SANDY CITY COMMUNITY DEVELOPMENT

MEMORANDUM

To: Planning Commission
From: Community Development Department
Subject: Wasatch Overlook Subdivision – Final Review SUB-05-17-5260
 10000 S. Wasatch Blvd., 3171 E. 10000 S., 10 Lots
 and 3140 E. 10000 S. 3.73 Acres
 (*Granite, Community #30*) Zoned R-1-15

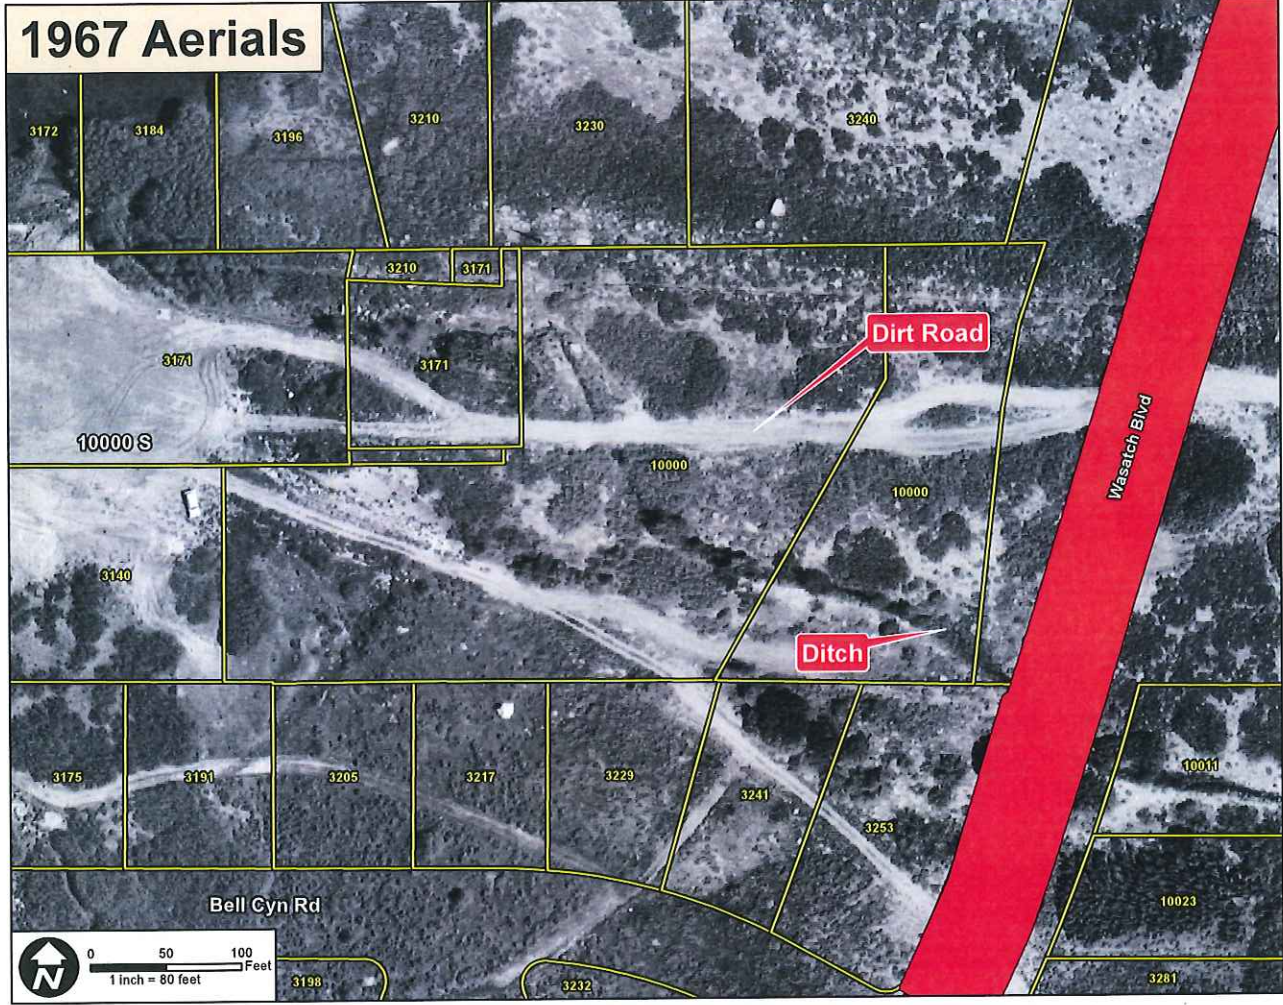
In accordance with the Sandy City Land Development Code, Chapter 15A-15 (Sensitive Area Overlay Zone), paragraph 5C (Determination of Anomalies for 30% or Greater Slopes), the property at the above address qualifies special exception to allow construction. Recommend that the man-made slopes, as identified on the plat and grading plan, be considered anomalies and construction be allowed on the property in question.

1. An irrigation ditch historically ran through the center of the parcel with a berm wall on the south side of the ditch. The remnants of this berm run diagonally through the parcel, from the northwest corner to southeast corner. This berm is man-made and an anomaly. See attached exhibit A for historical photography.
2. Wasatch Blvd was built by cutting the parcel at the east end. The 3:1 slope (33%) that was cut to accommodate Wasatch Blvd still exists on the east of the parcel and is also identified as an anomaly. See attached exhibit A for historical photography.

LOT 8 - SECTION 'A'

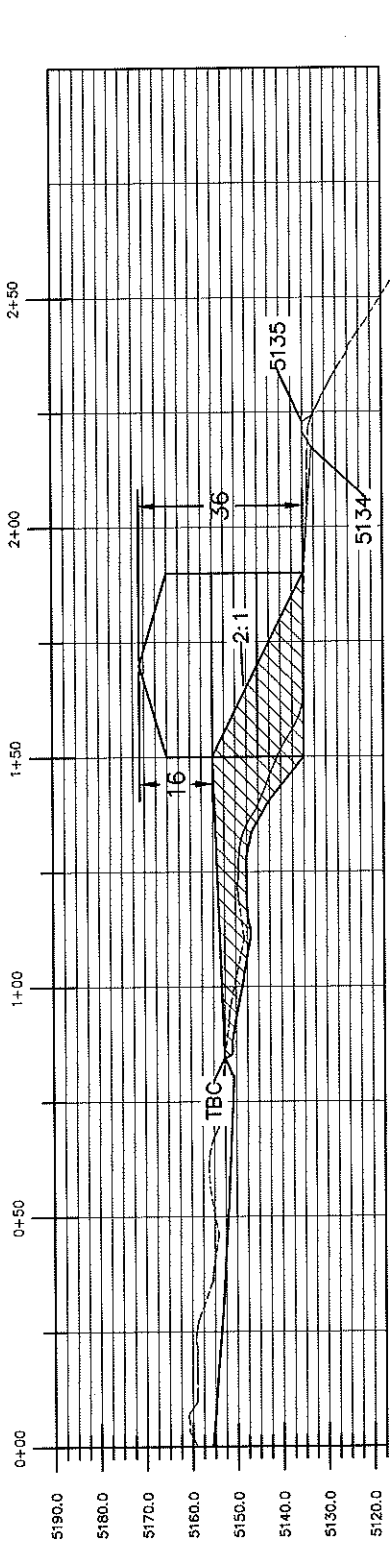
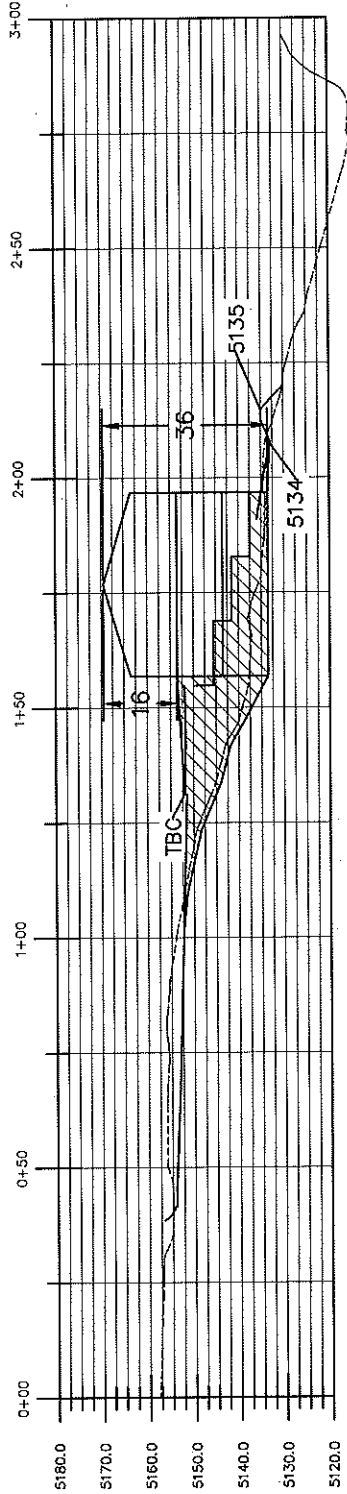
1. Staff suggested to the applicant to combine lots 7 and 8 in order to mitigate the possible impacts on the adjacent properties to the south. The applicant submitted the final plans showing 10 lots as in the preliminary plat with all requested information. The reviewing departments are comfortable with the drawings as submitted. Many of the details will be figured out to ensure compliance with the individual building permit applications (*See Exhibit #4 – Public Utilities and Public Works Approvals*). If the Planning Commission does not feel that the negative impact has been, or can be mitigated, they may still decide to combine these two lots. This would spread out the 30% slope over a larger area mitigating the impact this would have regarding storm water runoff and the construction of an imposing home.

2. Staff is also concerned with the amount of fill shown on the home placement plan cross section. This fill will provide ample area to construct a home on the properties and provide more level driveways, but at the same time, it will create an imposing structure on the rear side of the property visible to the residents to the south. This could also create an impact of storm water to the south.

18. That the 20-foot access west of the cul-de-sac be labeled on the plat as a 20-foot pedestrian access in addition to the emergency access.
19. That the home placement plans be approved for lots 7 and 8 as submitted by the applicant.
